DEPARTMENT OF TRANSPORTATION

14 CFR Part 25

[Docket No.: FAA–2022–1544; Amdt. No. 25–152]

System Safety Assessments

Figure 1 Factor of safety at the time of occurrence

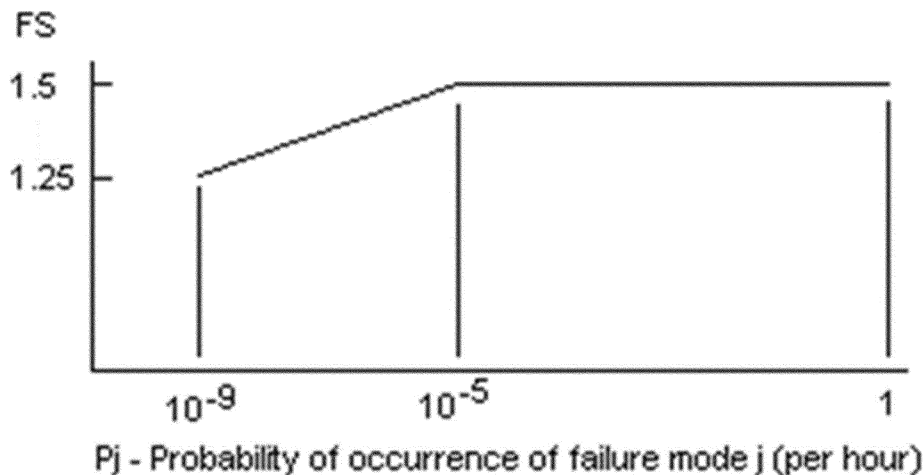
At the time of occurrence, the applicant must determine the loads occurring at the time of failure and immediately after failure. For static strength substantiation, the airplane must be able to withstand the ultimate loads determined by multiplying the loads by a factor of safety related to the probability that the failure occurs. The factor of safety (F.S.) is shown in Figure 1.

Figure 1 shows the factor of safety to be constant at 1.5 between a probability of failure of 1.0 and 10^{-5} , and between 10^{-5} and 10^{-9} declines linearly from

Figure 2 Factor of safety for continuation of flight

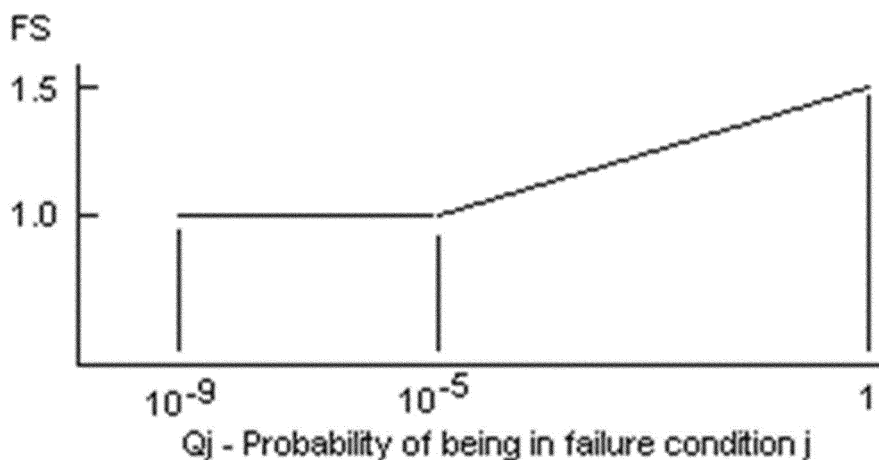
For static strength substantiation, the structure must be able to withstand the loads determined in § 25.302(c)(2)(i) multiplied by a factor of safety, as shown in Figure 2.

Figure 2 shows the factor of safety falls linearly from 1.5 to 1.0 as Q_j declines from 1 to 10^{-5} , and the factor of safety is constant at 1.0 between 10^{-5} and 10^{-9} , where $Q_j = (T_j)(P_j)$, where T_j is the average time in the failure condition (in hours), and P_j is the probability of failure (per hour) or failure rate. So Q_j is the (average) cumulative probability of failure. In contrast to the F.S. at the time of failure occurrence (Figure 1), the F.S. for continuation of flight (Figure 2) is allowed to fall immediately below 1.5 as failure probability falls from the highest probability of 1, and in contrast to the minimum F.S. of 1.25 for Figure 1, the Figure 2 safety margin is allowed to fall to 1.0 at 10^{-5} , where it remains as the probability of failure falls to extreme improbability at 10^{-9} . As with Figure 1,

note that the Figure 2 probability of failure axis is in logarithmic scale.

Figure 1 to paragraph (c)(1)(i)

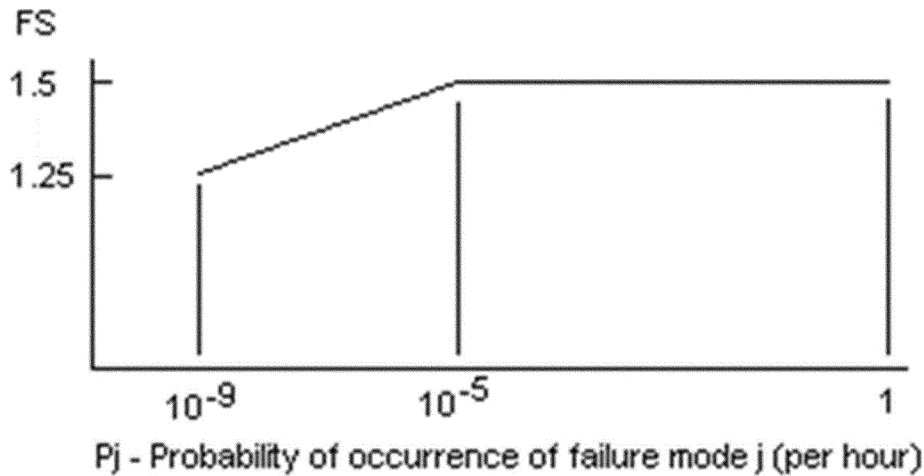
(i) For static strength substantiation, the airplane must be able to withstand the ultimate loads determined by multiplying the loads in paragraph (c)(1) of this section by a factor of safety that is related to the probability of occurrence of the failure. The factor of safety (F.S.) is defined in Figure 1.

Figure 2 to paragraph (c)(2)(ii)

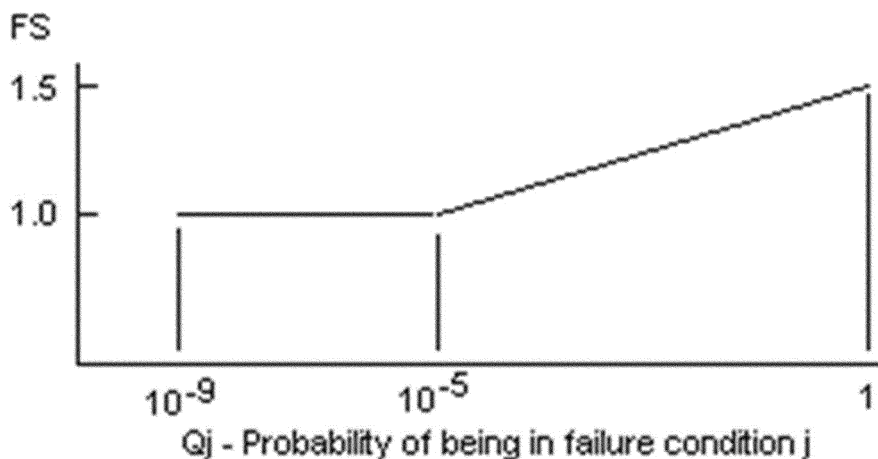
(ii) For static strength substantiation, each part of the structure must be able to withstand the loads in paragraph (c)(2)(i) of this section multiplied by a factor of safety that depends on the probability of being in this failure condition. The factor of safety is defined in Figure 2.

$Q_j = (T_j)(P_j)$ where:
 T_j = Average time spent in failure condition j (in hours)
